UNITED STATES PATENT AND TRADEMARK OFFICE

APPLICATION NO.	FILING DATE	FIRST NAMED INVENTOR	ATTORNEY DOCKET NO.	CONFIRMATION NO.
10/690,388	10/21/2003	Vladimir Gurevich	1549	2379

Office Action Summary

DETAILED ACTION

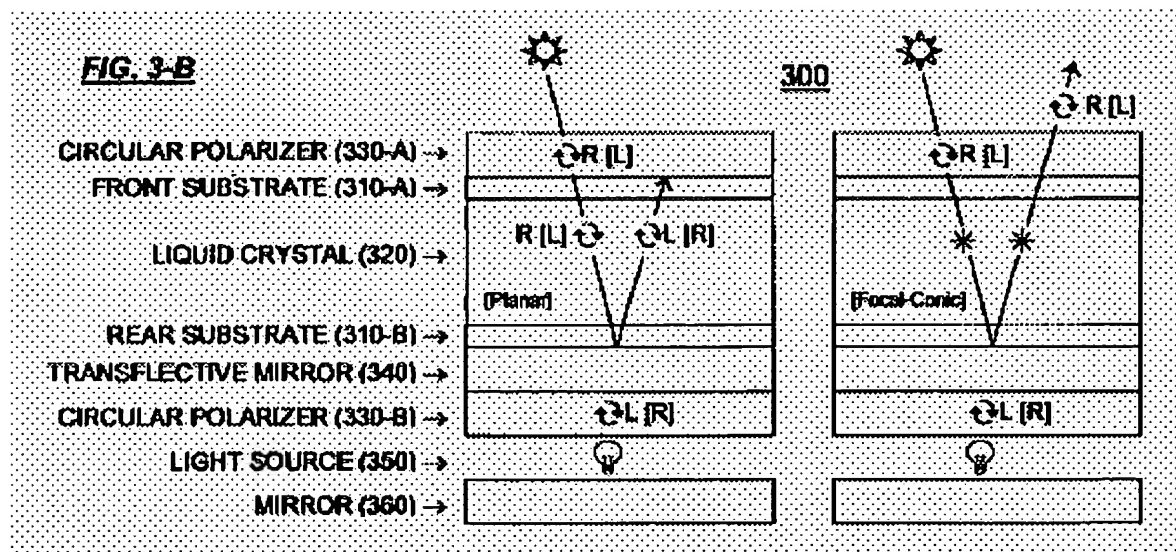
Claims 4-5, 14-15, Wu discloses (col.4, lines 36-39) that the device is a reflective display using a front-lit (front light).

Claim 11, Wu discloses (Figs.3A,3B) that using a liquid crystal display (310-A, 320, 310-B) between the two circular polarizers (330-A, 330-B) generating images.
